Project: Central Development Addition

Response to comments for Central Development Addition from 12-29-2005

**DRAINAGE REPORT
FOR**

**CENTRAL DEVELOPMENT ADDITION
DRAINAGE ANALYSIS
NOVEMBER 2, 2005**

Drainage Plan

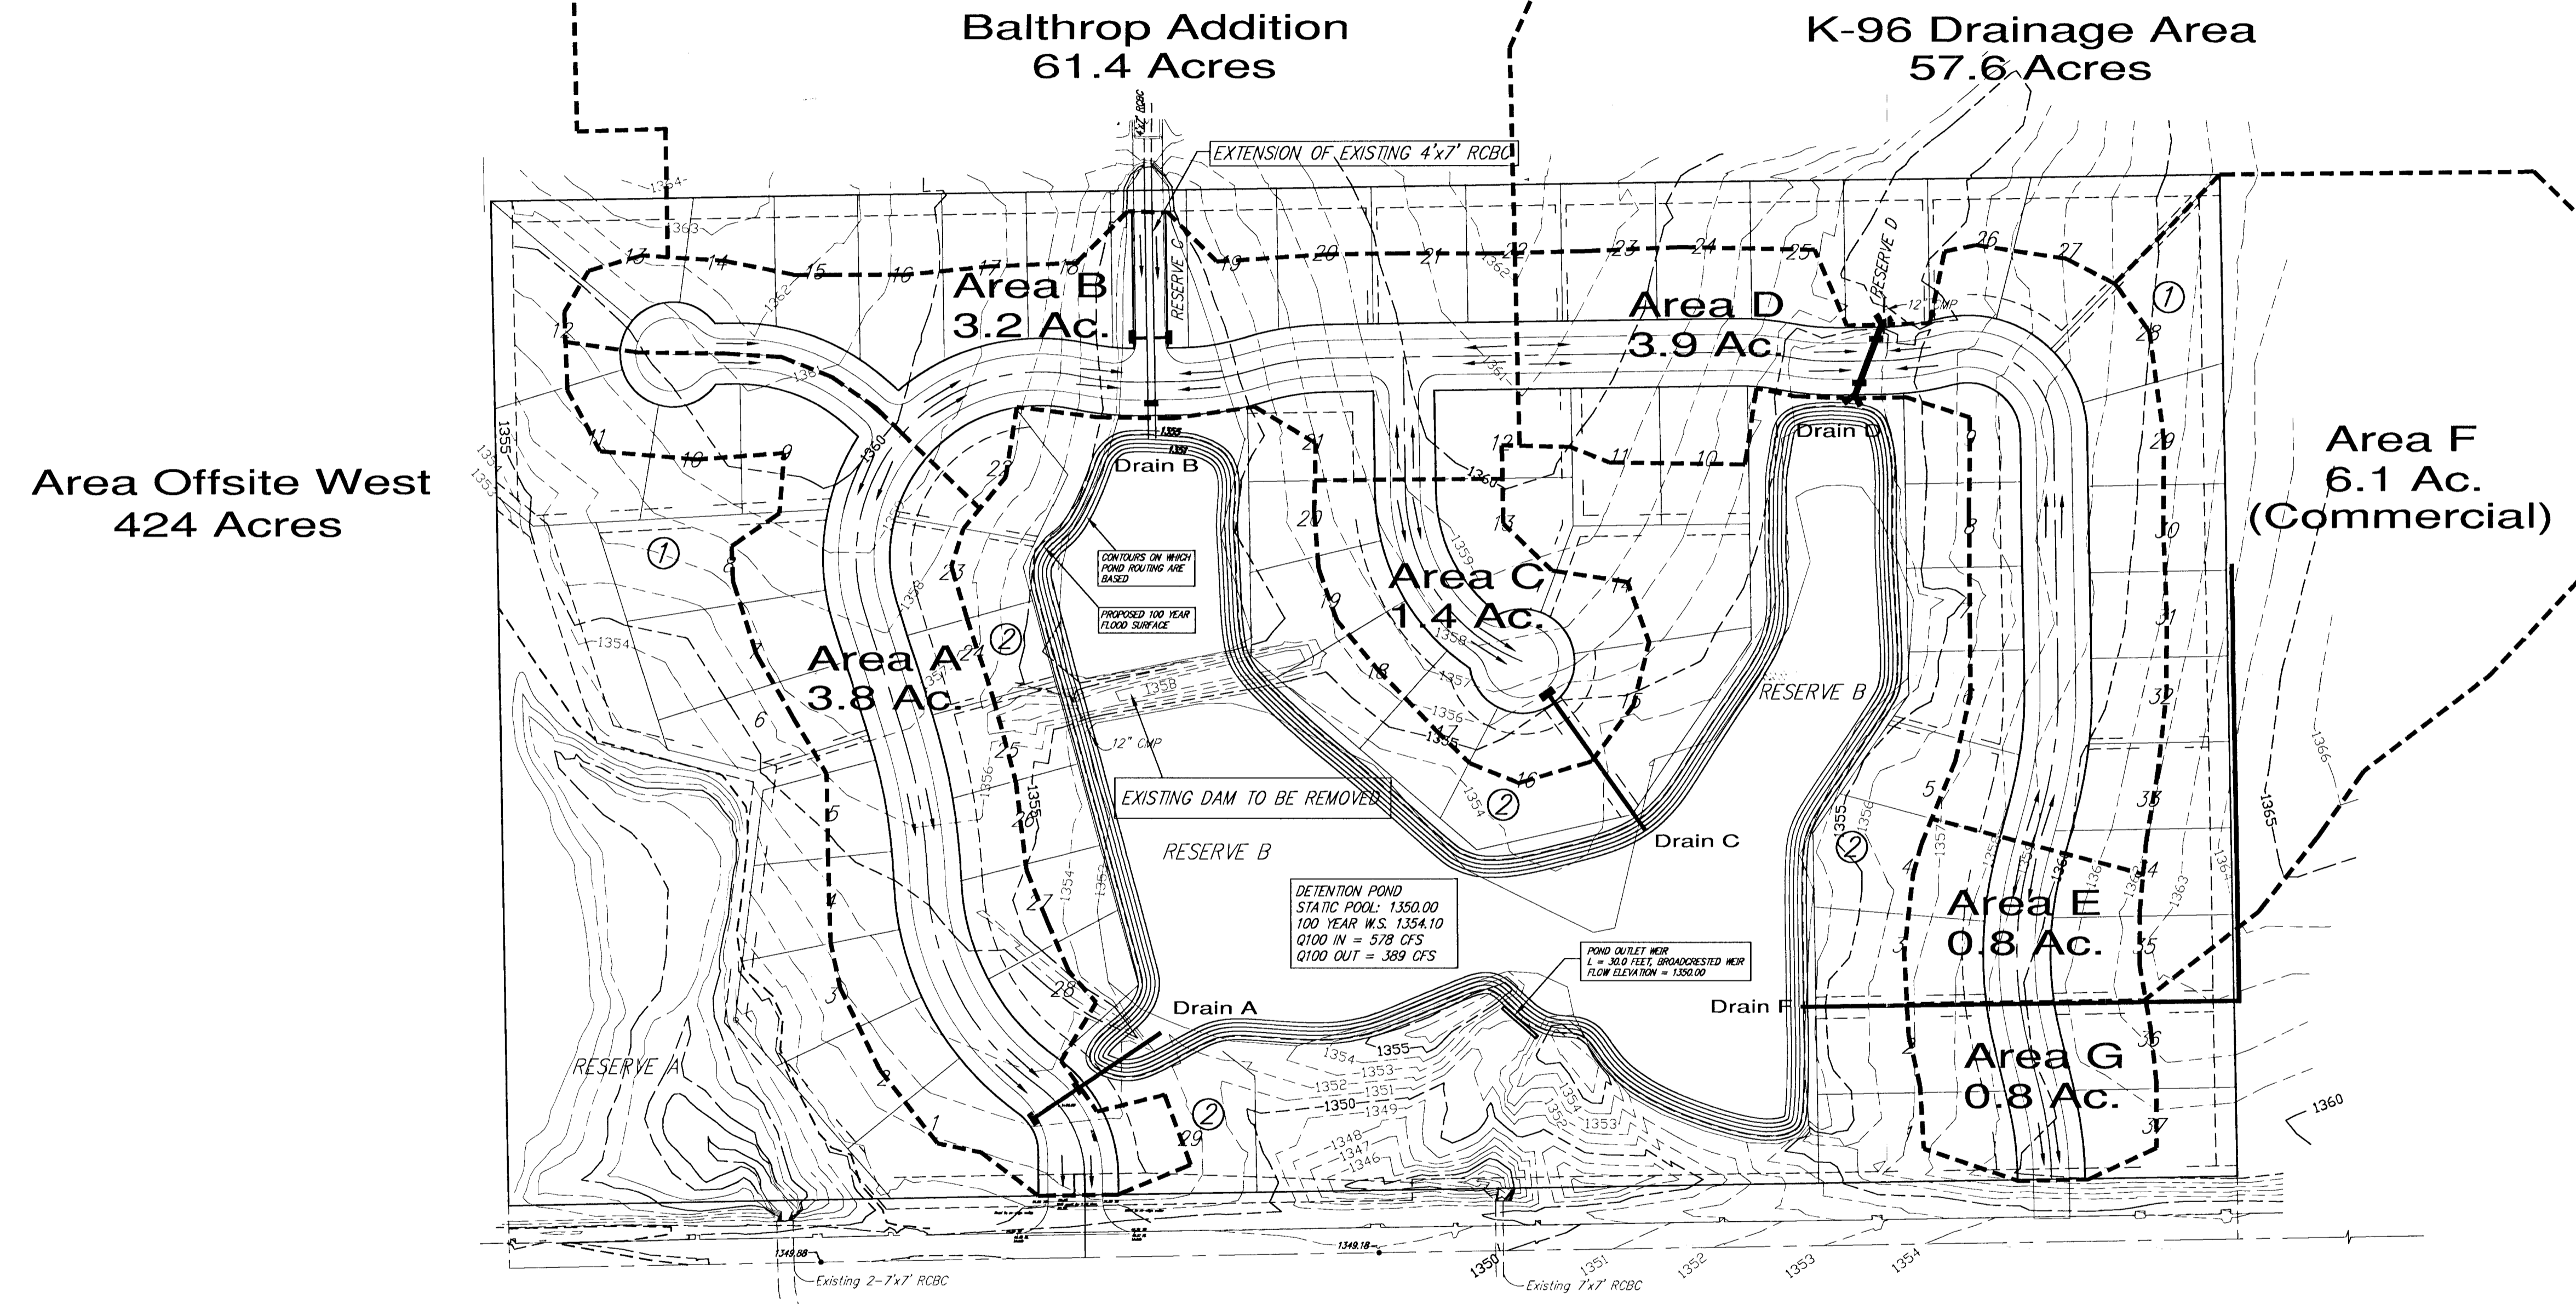
Why does the drainage plan show the Q100 out is 434 cfs?

3. The drainage plan shows the west 424 acre offsite drainage to be discharging 1153.7 cfs under a hundred year condition and the box was rated using HY-8 only up to flow 1029.3 cfs, where it would overtop the road at elevation 1349.9. The model should include the elevation and flow of the peak flow calculated using HEC-HMS (1153.7). Please revise and show the flow rates and water surface elevations on the plan. The 100-year flood boundary should be shown on the plan. Bold line. It appears the 100-year water surface backs up on lots 2 and 3, Blk 1. Please revise proposed grades or define within a drainage easement as necessary.

The outlet structure has been designed to reduce the outflow of the pond to less than or equal to the existing condition. The drainage plan has been corrected.

The peak flow of the west tributary area and the overtopping elevation is shown in the culvert data table. The information has been circled to aid in identification. Lots 2 and 3, Block 1 have been provided with a drainage easement.

Grading Plan

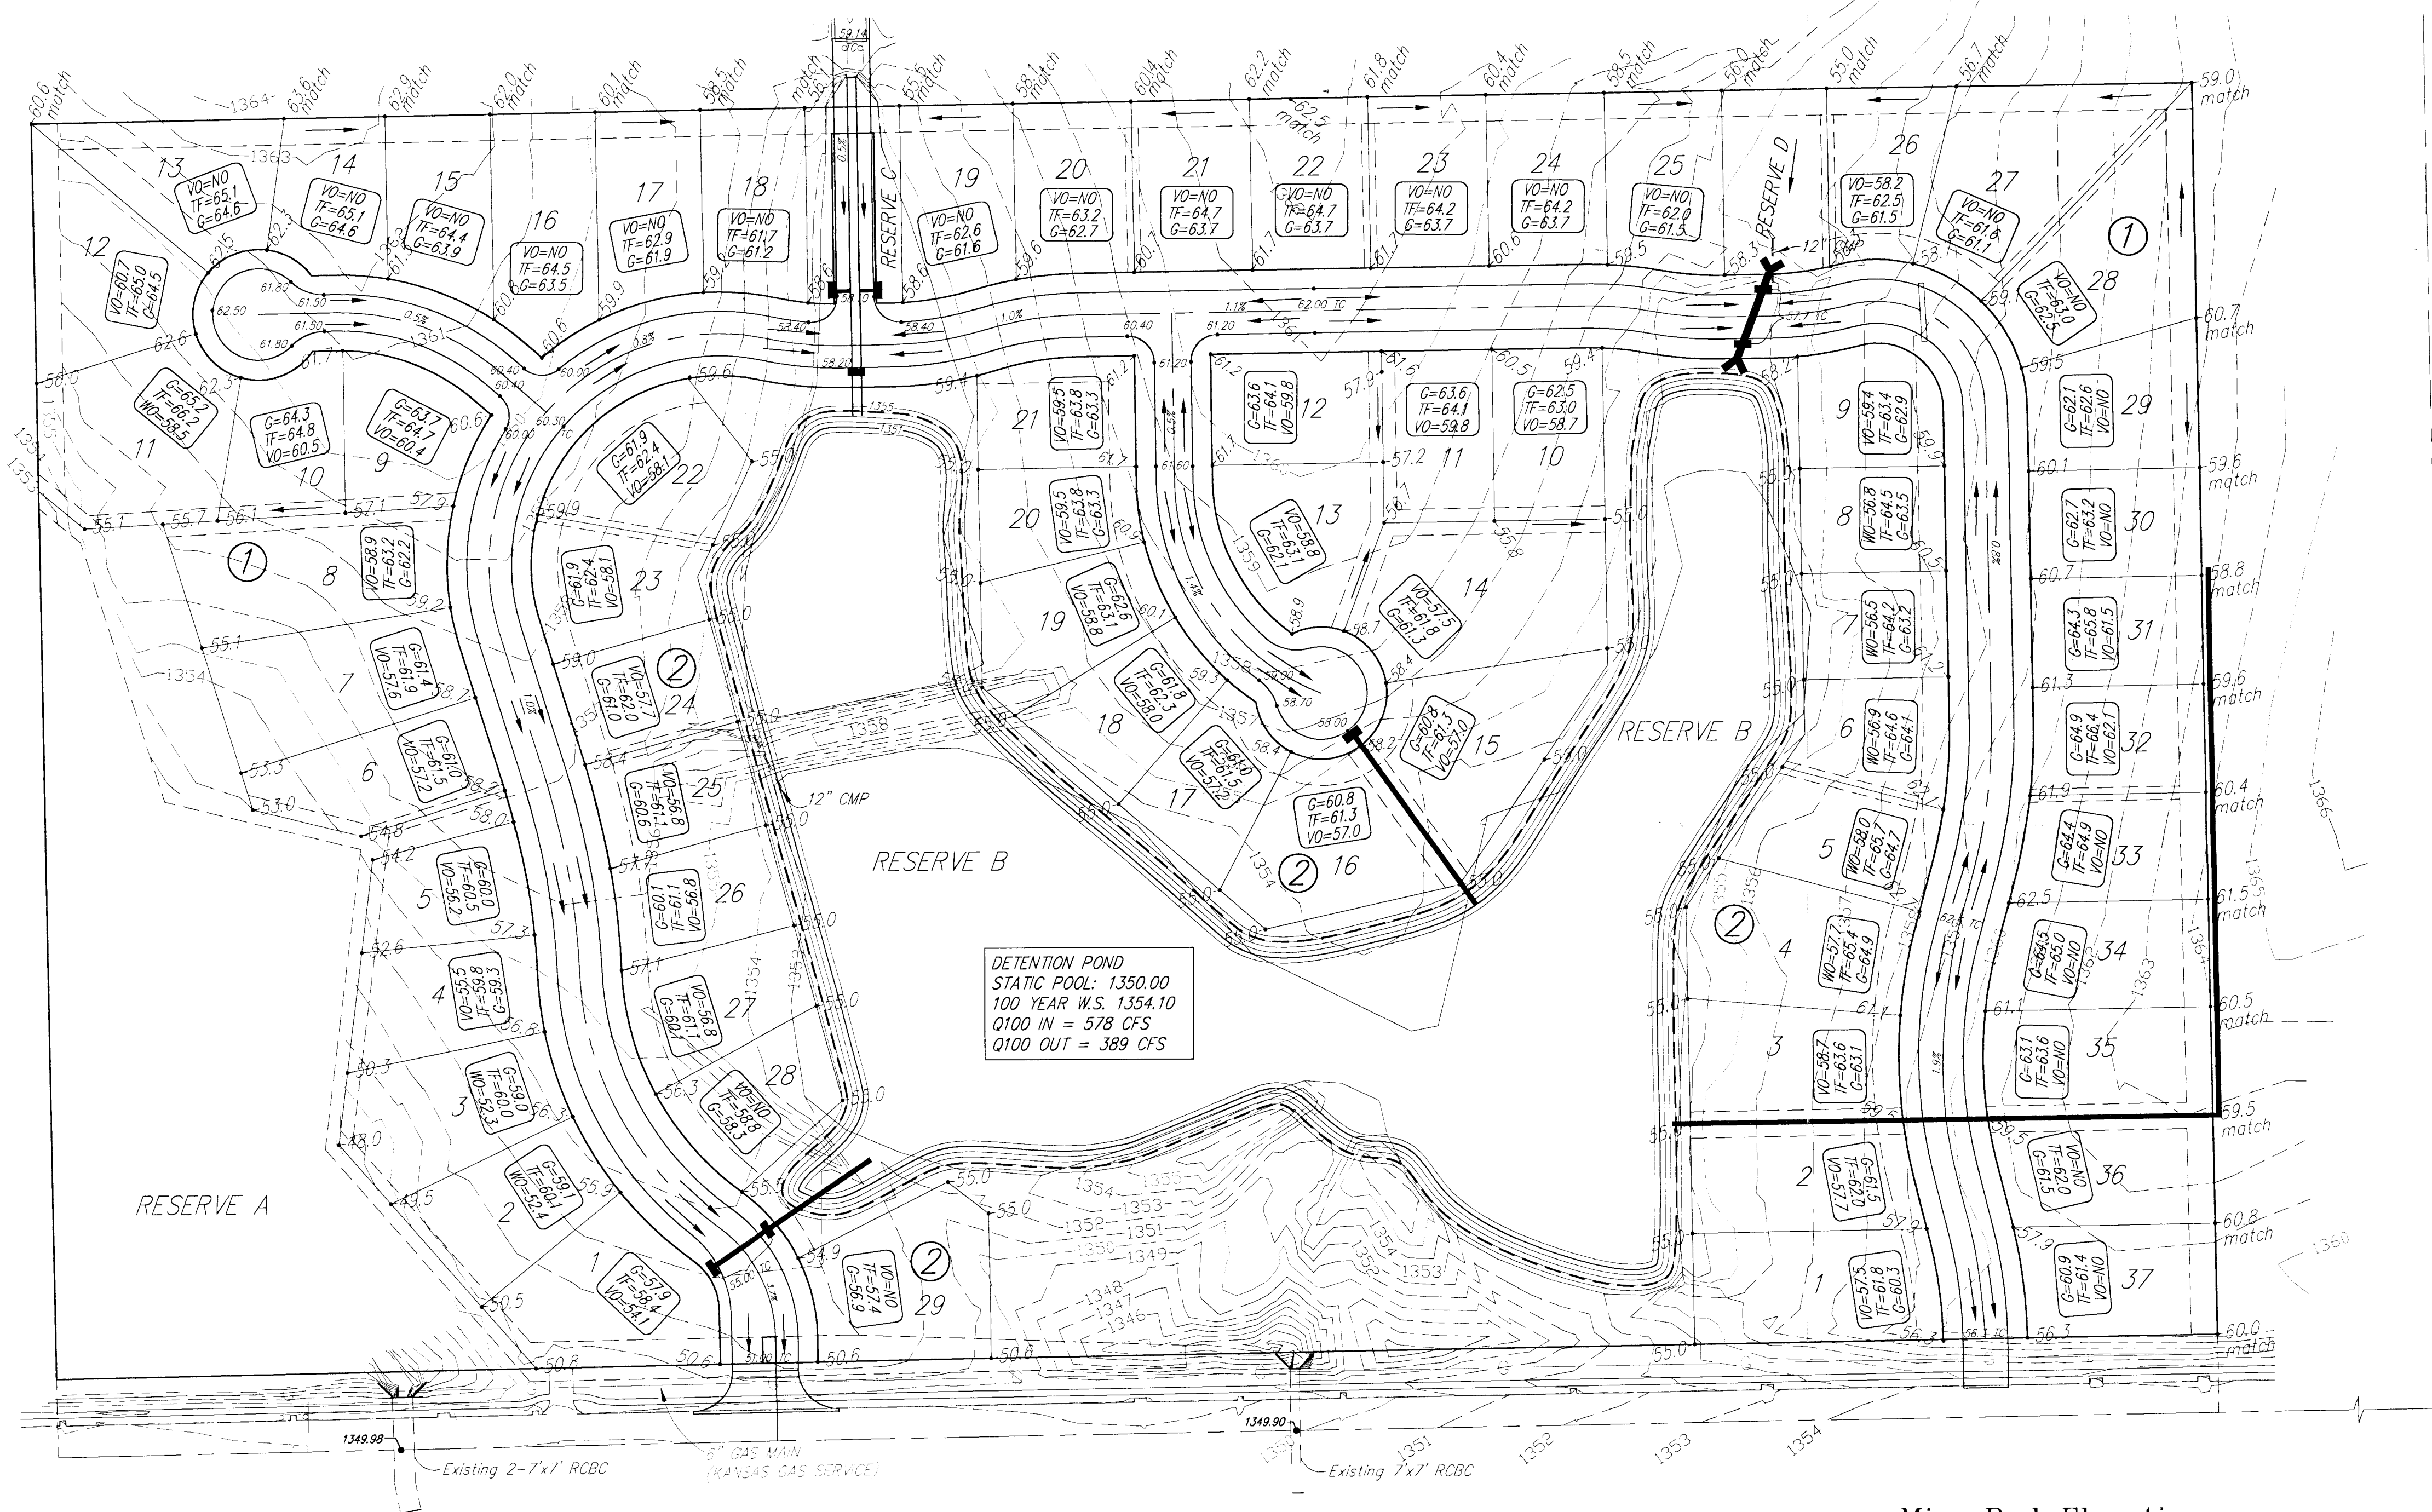
5. The grading plan should show the drainage easements, updated topography, inlet top elevations, prop. contours, flow arrows, prop. contours, and plat's min. pad elevations.

6. It appears the grading around the perimeter boundary of the plat does not contain the drainage within the plat. The grading plan should show the match elevations at the property line and the plat's internal grading within the drainage easement. Please revise as necessary. The grade across the backyard of lot 22, Blk 1 does not meet the minimum 1% grade requirement.

The information requested has been provided, except for the proposed contours. The level of detail and information provided is sufficient, and any proposed contours would not be an accurate representation of ultimate conditions.

The plat accepts drainage wherever offsite drainage comes onto it and the match elevations are provided around the perimeter. The backyard grades of Lot 22, Block 1 comply with the 1% minimum requirement.
